Subject: AP1000 Response to Request for Additional Information (TR 09)

AP1000 TECHNICAL REPORT REVIEW

RAI Response Number: RAI-TR09-004
Revision: 3

1. APP-MV50-GEC-001, Revision 1, "Verification of AP1000 Containment Vessel Not Requiring Analysis for "Cyclic Service Report"."
2. APP-GW-GLR-005, Revision 3, "Containment Vessel Design Adjacent to Large Penetrations"

Figure 2-6(c) – Equipment Hatch (El. 141'-6") Panel – Vertical Section

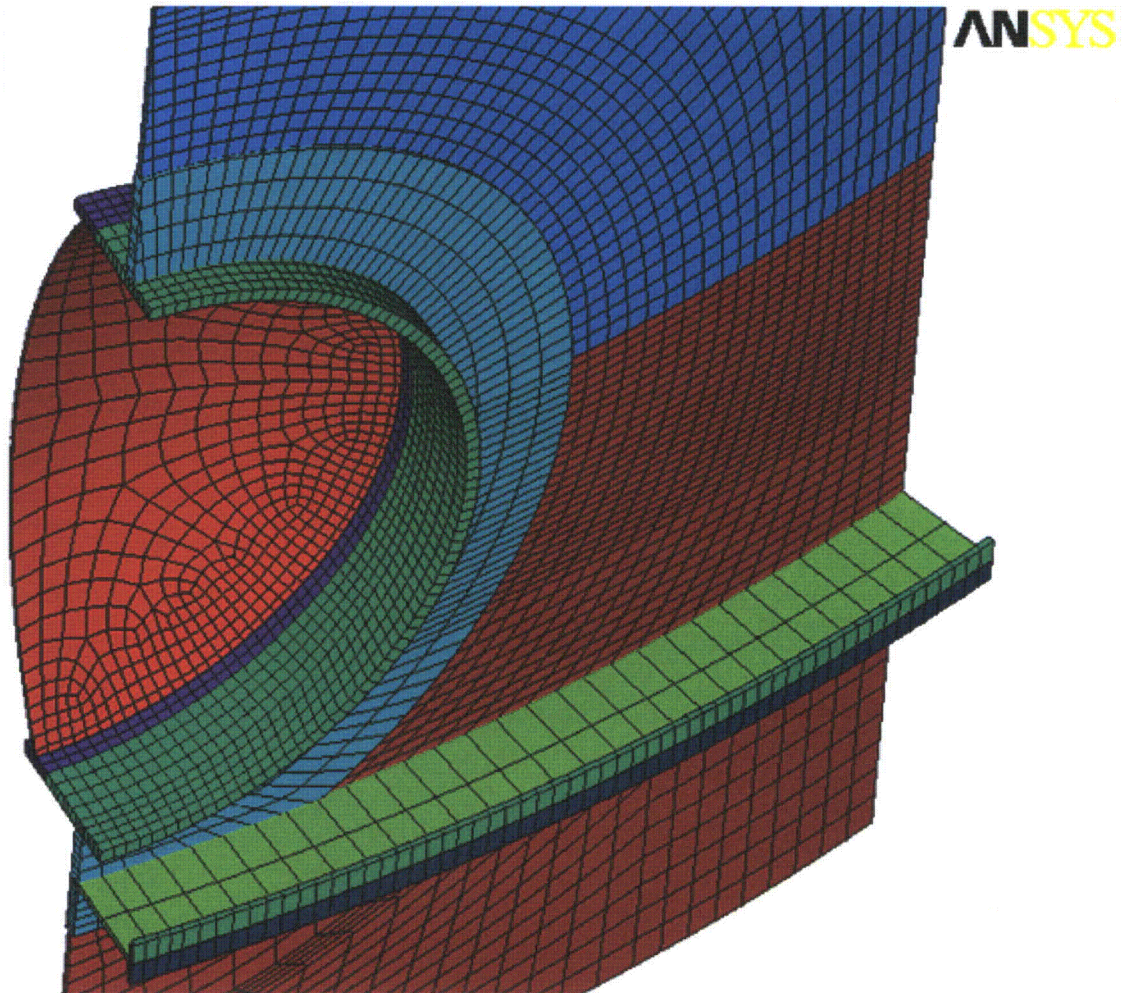
There is insufficient description in TR-9 of the local ANSYS models developed for the penetrations. For each penetration, the staff requests the applicant to address the following in TR-9:

Subsequent to the initial response to this RAI the NRC requested a revised Figure 2-6(b) in APP-GW-GLR-005 to show the thickened portion of the containment. An additional figure to supplement Figure 2-6(b) is shown below and will be added to the technical report.

The coarsely meshed panels around the openings in the dynamic model were replaced by the refined mesh panels. The refined model used in static analyses to evaluate the large penetrations is shown in Figure 2-6(a). The refined submodel for the upper equipment hatch is shown in Figures 2-6(b) and 2-6(c).

Add Figure 2-6(c) as follows:
